# **Response to Comment #80 and Proposal for an alternate 45/46 code for KP4**

**for IEEE 802.3bj 100GBASE-KP4 task force  
Geneva**

## Comment #80 from Charles Moore

# Proposal for Modified KP4 Format

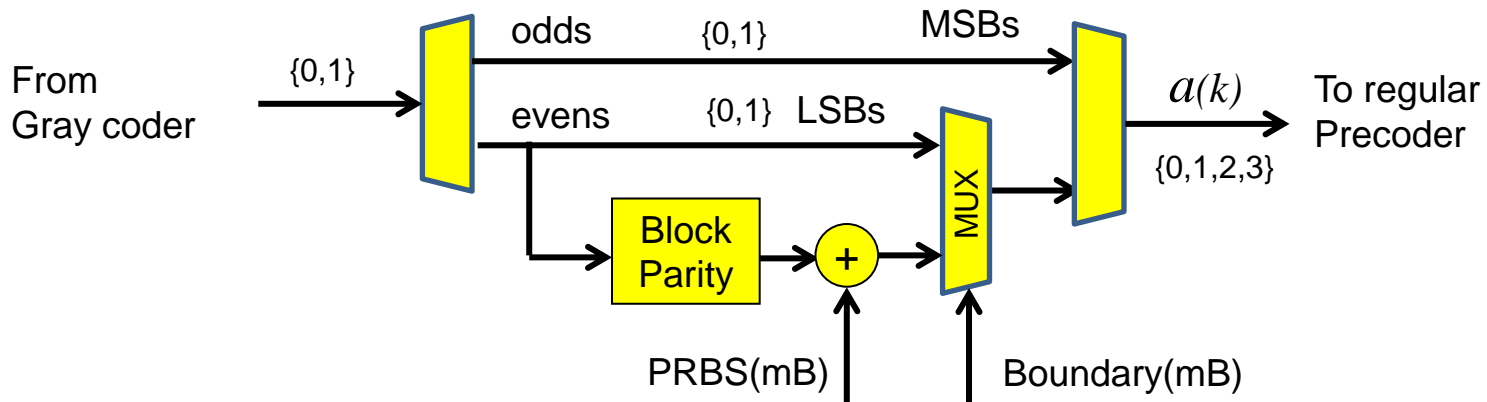
- A PSP scheme can be applied to detect errors with Partial Response (PR) Extended Slicer Detectors.
- A simple 45/46 code can detect single bit errors.
  - Can we make such a code still support block parallel VA implementation?
- The current PSP scheme disallows implementation of the simple and low latency detector, the PR Extended Slicer.
  - The extended slicer requires all symbols must be precoded, which current PSP violates
- We'd like a 45/46 PSP scheme that 'partially pins' the channel states, that precodes all the symbols, and that can be used for error detection and/or correction with all detectors

- Based on a variant of PSP denoted ‘constant power termination symbol’ where the channel  $x(k)$  state pinning was either on the set  $\{0,2\}$  or on the set  $\{1,3\}$ , and where the choice of set was driven by a PRBS
  - The choice within a set is the 1-bit of ‘user information’
  - The PRBS choice of set sufficiently ‘randomizes’ the selection to keep the power spectrum both white and time-invariant
  - Presented in reference [Dabiri\_01a\_0112] backup slides
- Proposal suggested by Dabiri is minor addition to ‘constant power termination’
  - The ‘MSB’ of the boundary symbol is the ‘one user bit’ on  $\{0,2\}$  (same as above)
  - Let the ‘LSB’ of the boundary symbol be PRBS (same as above) XORed with a parity over the 22 user symbols

$$LSB\{a(mB)\} = PRBS(mB) + \sum_{k=1}^{22} a(mB - k) \quad \text{all Modulo}(2)$$

- The PRBS can be thought of as randomizing between even and odd block parity
- Because  $a(k)$  is PAM-4 on  $\{0,1,2,3\}$ , this sum ignores the MSBs, and is a parity on the LSBs
- All symbols, including the boundary symbols, are input to the precoder, which is never ‘forced’ or ‘set’
